From: Comar, Manny
Sent: Wednesday, October 03, 2012 7:53 AM
To: TurkeyCOL Resource
Subject: FW: DRAFT RAI Responses FPL Turkey Point 6 & 7 for eRAIs 6006 & 6184 Stability of Subsurface Materials and Foundations
Attachments: Draft Revised Response for NRC RAI Letter No. 040, RAI 02.05.04-1 (eRAI 6006).pdf; Draft Revised Response for NRC RAI Letter No. 040, RAI 02.05.04-25 (eRAI 6184).pdf

NRC RAI Letter No. PTN-RAI-LTR-040

SRP Section: 02.05.04 - Stability of Subsurface Materials and Foundations

NRC RAI Number: 02.05.04-1 (eRAI 6006)

Figure 1. Line 10 Geophysical Data

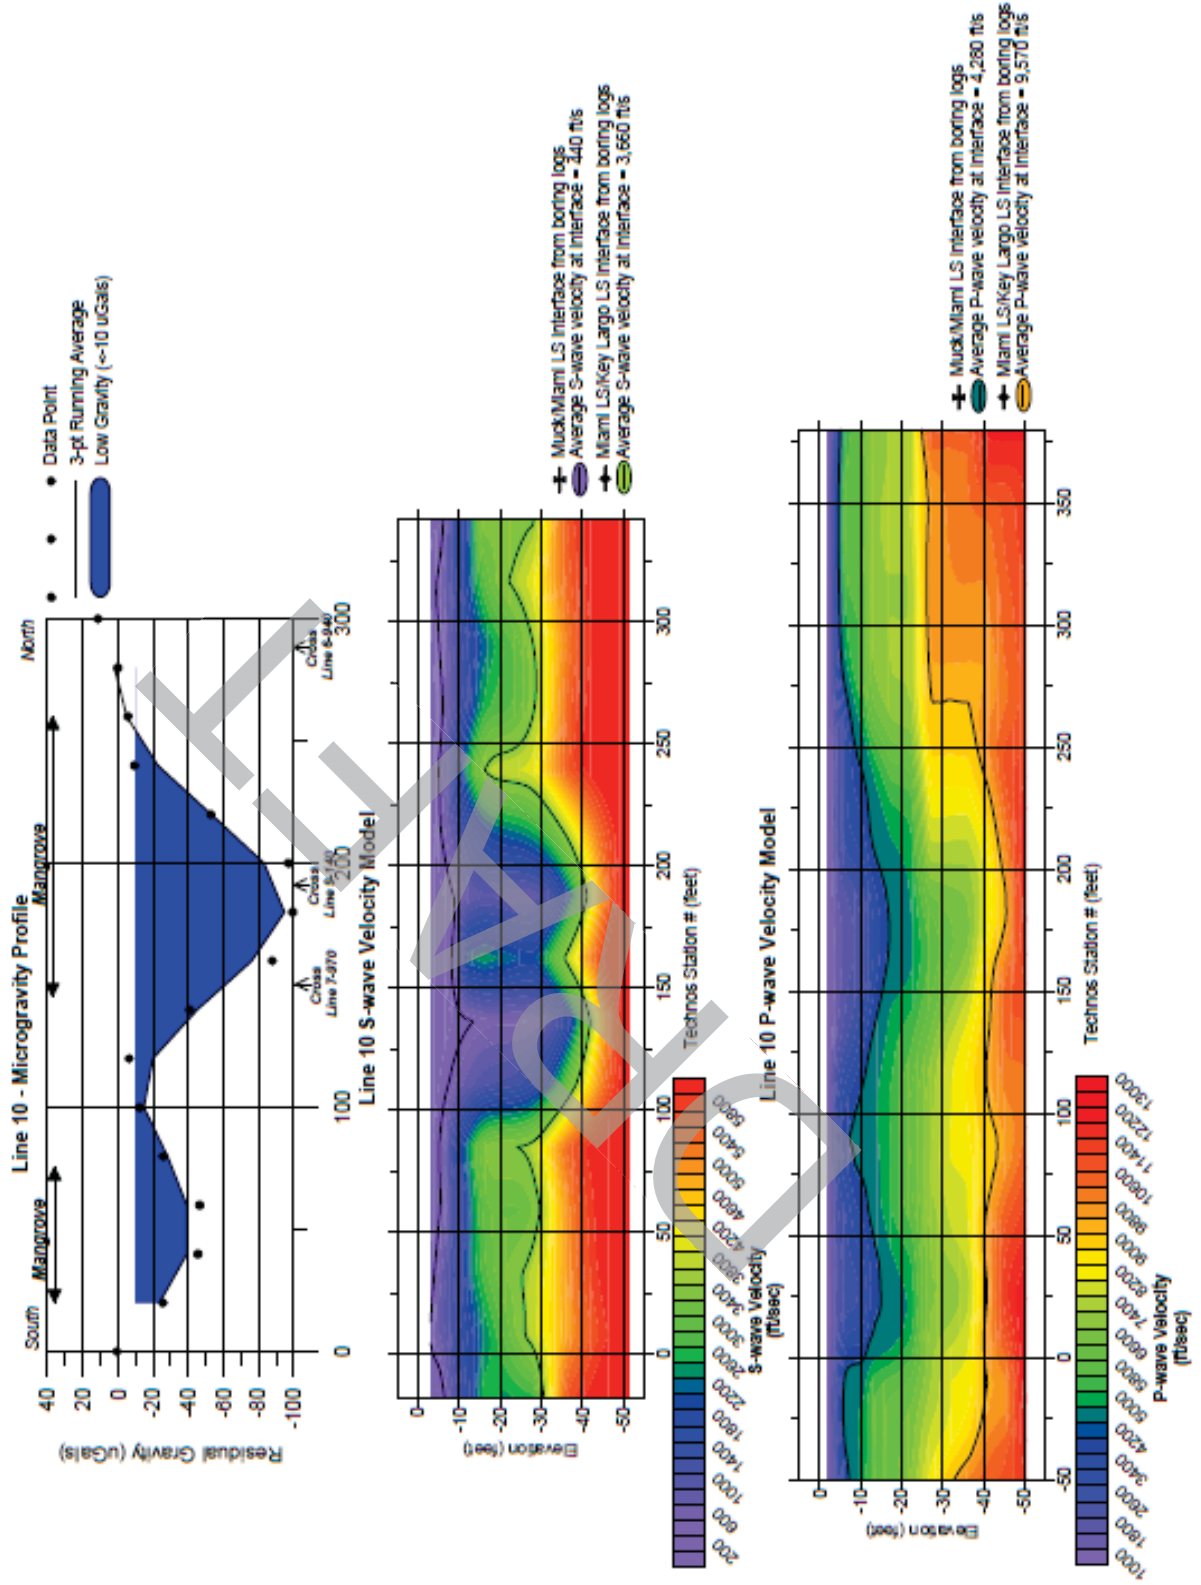
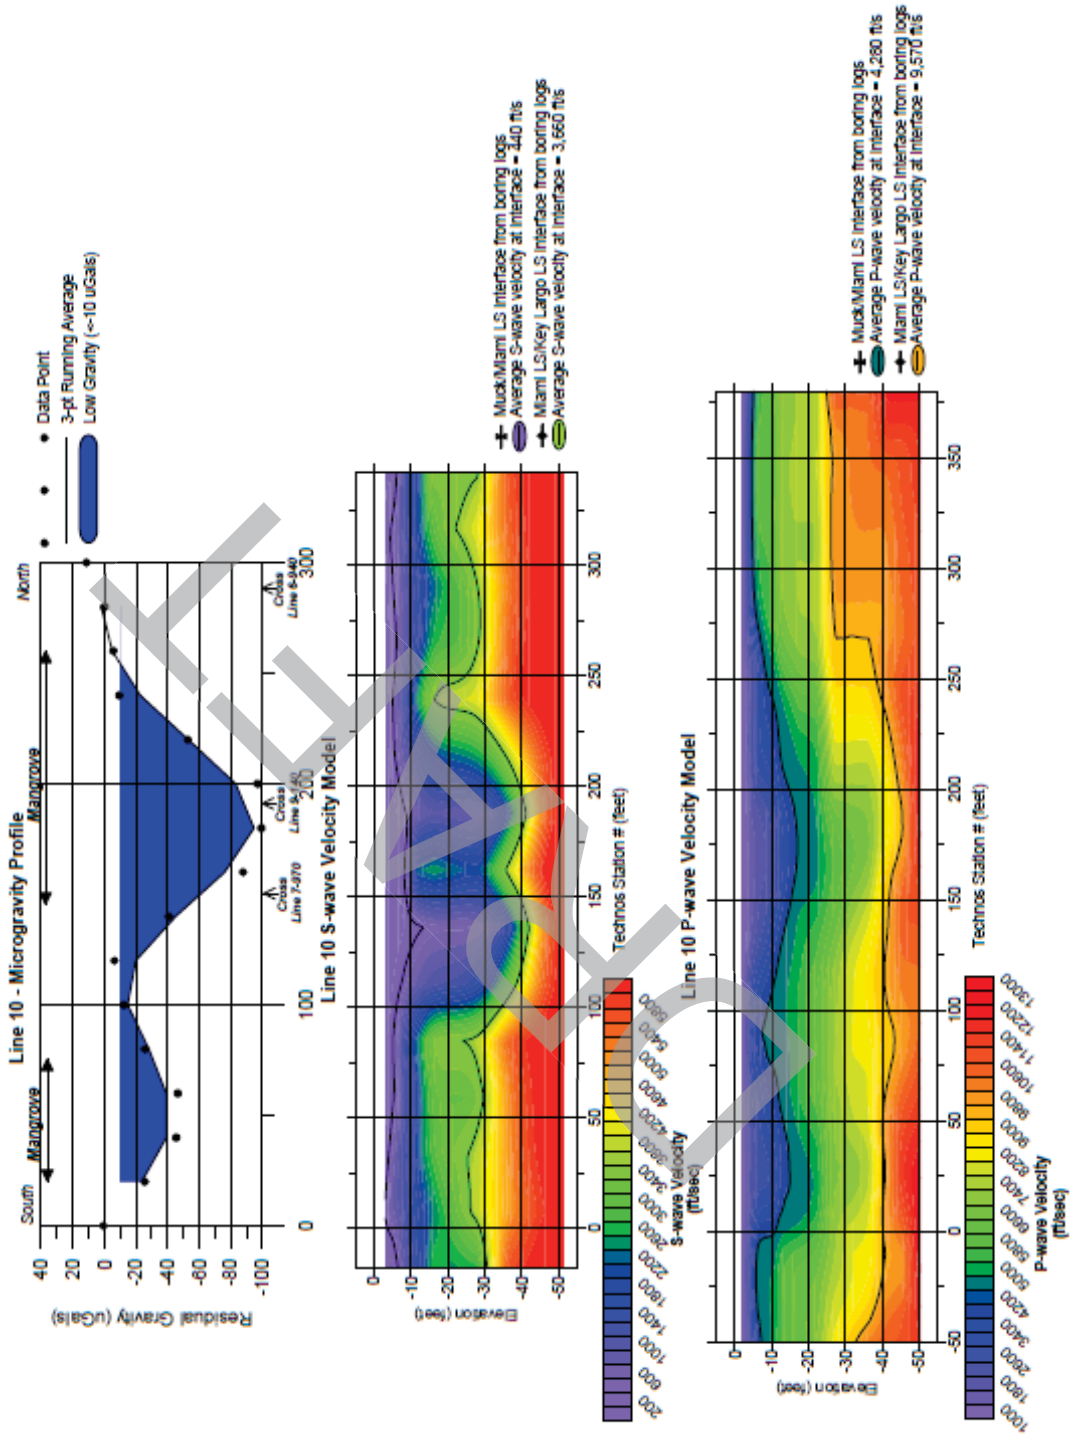
FSAR Section 2.5.4.1.2.1 presents a discussion on dissolution activity in the limestone formation, including potential cavities at depths. Among the data sets used to assess the potential existence of cavities is the microgravity data presented in Figures 2.5.4-224 through 231 which provide insights into the existence of potential cavities in at the site. Based on the analysis of gravity data analyses, this section concludes that there are no large cavities underneath the site. In accordance with NUREG-0800, Standard Review Plan, Chapter 2.5.4, "Stability of Subsurface Materials and Foundations," and Regulatory Guide (RG) 1.132, "Site Investigations for Foundations of Nuclear Power Plants" please provide additional discussion on the adequacy of the assumptions used in the microgravity data analyses. Since only profile measurements were made and large gaps remain between profiles throughout the site area, please justify your assumption that no large cavities exist throughout the site. Also, please provide additional references and data sources used to reach this conclusion.

The assumptions used in the microgravity data analysis include assuming that a spherical, water-filled cavity would have a sufficient density contrast with the surrounding limestone to produce a microgravity anomaly. The density contrast is based on laboratory test and published data summarized in the FSAR Subsection 2.5.4.4.5.4 and on experience conducting similar geophysical surveys in south Florida. A spherical cavity was used in the analysis as the most conservative approach since it represents the most compact form of "missing mass," and therefore produces the smallest gravity anomaly for a given cavity diameter. Other geometric distributions of a cavity, having the same diameter as the sphere, would produce a significantly larger gravity anomaly. The detectability of the anomaly varies with cavity size, depth, and location with respect to the survey line.

To further reduce any uncertainties in the resolution and interpretation of microgravity data with depth, and away from geophysical survey lines and boreholes, FPL proposes a commitment to conduct a microgravity survey on the base of the nuclear island (NI) excavation. The current excavation concept is to grout the excavation as part of the dewatering program. FSAR Subsection 2.5.4.5.4 describes the dewatering and excavation methods. The installation of a grout plug, approximately 25 feet thick, to prevent vertical seepage is described in FSAR Subsection 2.5.4.6.2 and, in more detail, in ER Subsection 3.9.1.7. The grout plug will be constructed from elevation -35 feet NAVD 88 to elevation -60 feet NAVD 88 by first drilling from the ground surface and then grouting. Vertical boreholes will be drilled in a grid pattern and grouted in an iterative process, which is estimated to consist of four rounds of drilling and grouting, prior to excavation. The grouting procedure described in ER Subsection 3.9.1.7 is expected to fill voids that may exist beneath the nuclear island excavation to an elevation of -60 feet NAVD 88. It is anticipated that the density of the grout will be similar to that of the foundation limestone and that the proposed microgravity survey will be designed to detect density anomalies below the grout plug that represent potential solution features with a diameter of 25 feet or greater if spherical and 12 feet or greater if cylindrical. Preliminary estimates indicate that a hypothetical solution feature with an approximate diameter of 30 feet at a depth immediately below El. -60 feet NAVD 88 will have a negligible effect on the stability of the nuclear island foundation, i.e., negligible effect on bearing capacity, settlement, or resistance to sliding. Such a cavity would cause an increase in stress levels in the vicinity of the cavity due to stress redistribution. However, the stresses from the design loading on the nuclear island at that depth are comparatively low (less than 50 psi) so that the effects are insignificant in the limestone of the Fort Thompson Formation with an average unconfined compressive strength of 2,000 psi (FSAR Table 2.5.4-209).

Figure 2.5.4-241 will be added to FSAR Subsection 2.5.4 in a future COLA revision:

Figure 2.5.4-241. Line 10 Geophysical Data
